# Access Compliance Report

## Public Rights-of-Way

Intersection ID: 52476	Main Street: WHITEHALL_EXECUTIVE_CENTER_DR	Cross Street: CERNY_DR	Location: NE
ADA ID: 310F913DD8F3	Ramp Type: Perp	Initial Pass/Fail: Fail	Overall Compliance: No
Severity Score: 12.5			
Codes/Mitigation Info/Possible Solution		Field Measurements/Component Compliance

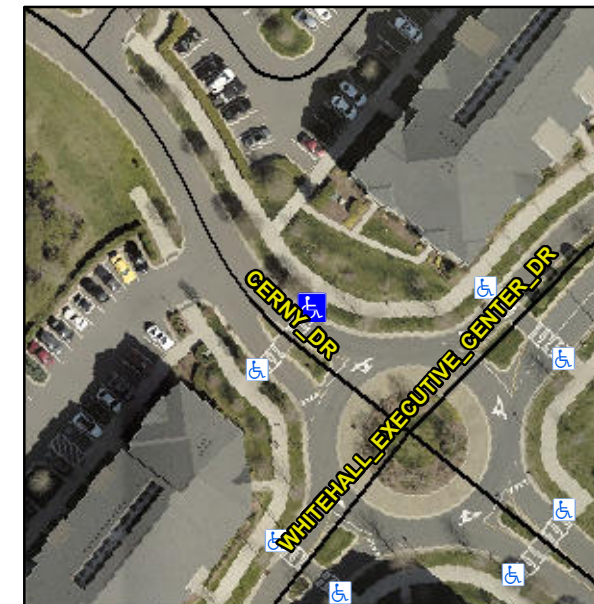
Compliance	Description	Data	Compliance	Description	Data
N/A	Ramp Length (in)	93.0	No	Ramp Slope (%)	8.8
Yes	Ramp Width (in)	89.0	Yes	Ramp XSlope (%)	1.4
N/A	Flare Type LT	N/A	N/A	Flare Type RT	N/A
N/A	Flare Slope LT (%)	N/A	N/A	Flare Slope RT (%)	N/A
N/A	Flare Traversable LT?	N/A	N/A	Flare Traversable RT?	N/A
N/A	Landing Length (in)	N/A	N/A	DWS Provided?	N/A
N/A	Landing Width (in)	N/A	N/A	DWS Contrast?	N/A
N/A	Landing Slope (%)	N/A	N/A	DWS Length (in)	N/A
N/A	Landing X Slope (%)	N/A	N/A	DWS Full Width?	N/A
N/A	Landing Curb? (Y/N)	N/A	N/A	DWS Offset (in)	N/A
N/A	Shared Landing?	N/A			
N/A	Gutter Ponding?	N/A	N/A	Gutter Slope (%)	N/A
N/A	Gutter Lip Ht (in)	N/A	N/A	Gutter X Slope (%)	N/A
N/A	Painted X Walk1?	Yes	N/A	Painted X Walk2?	N/A
	X Walk 1 Direction	To SW		X Walk 2 Direction	N/A
N/A	X Walk 1 Width (in)	94.0	N/A	X Walk 2 Width (in)	N/A
	X Walk 1 Slope (%)	4.3		X Walk 2 Slope (%)	N/A
	X Walk 1 X Slope (%)	0.2		X Walk 2 X Slope (%)	N/A

**Remove & Replace Entire Ramp.**

**R304.2.2**
